Note to File

Subject: Consultation Reevaluation

Project Name: GP I-2

SH 99 SEGMENT I-2B
EB FRONTAGE ROAD
REALIGNMENT

EXHIBIT C

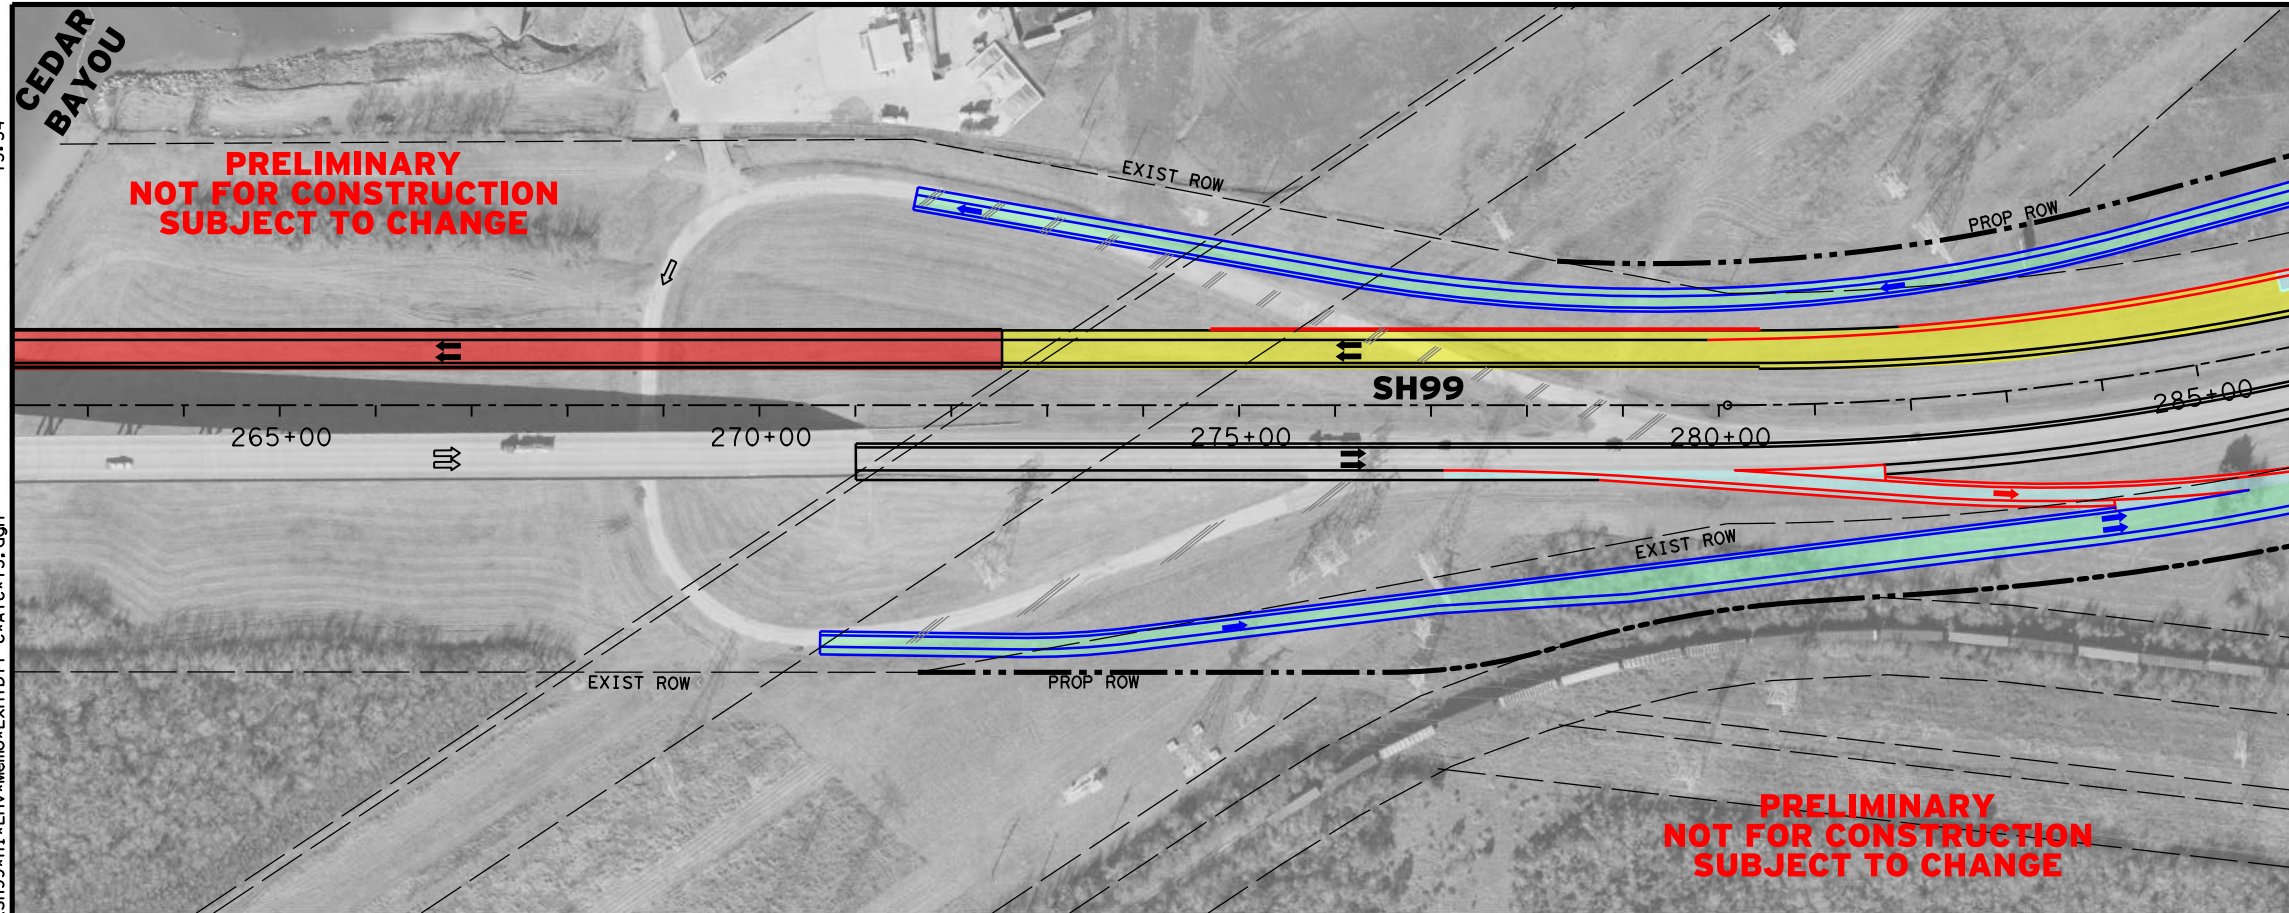
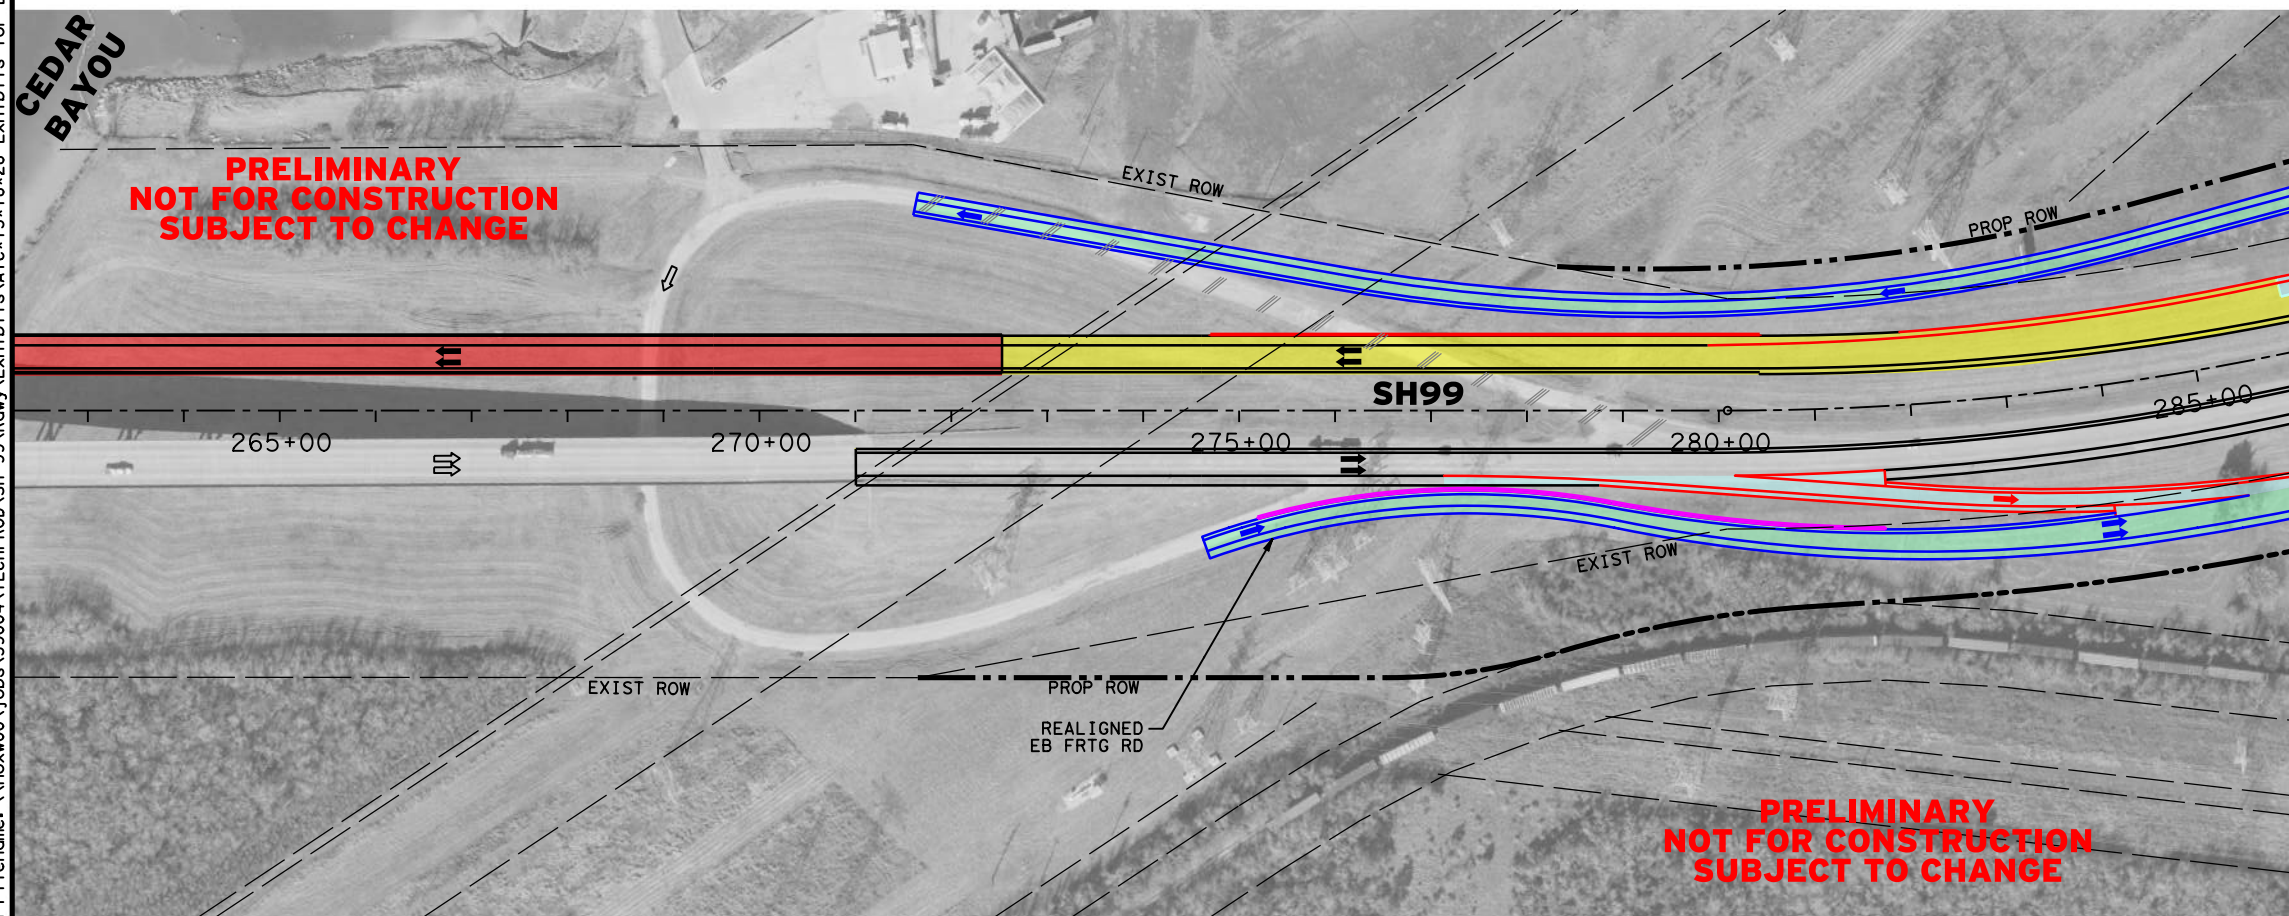
The proposed change is a U-turn under Cedar Bayou Bridge on the east side designed further north towards the existing U-turn to avoid Center Point Utility relocation issues.
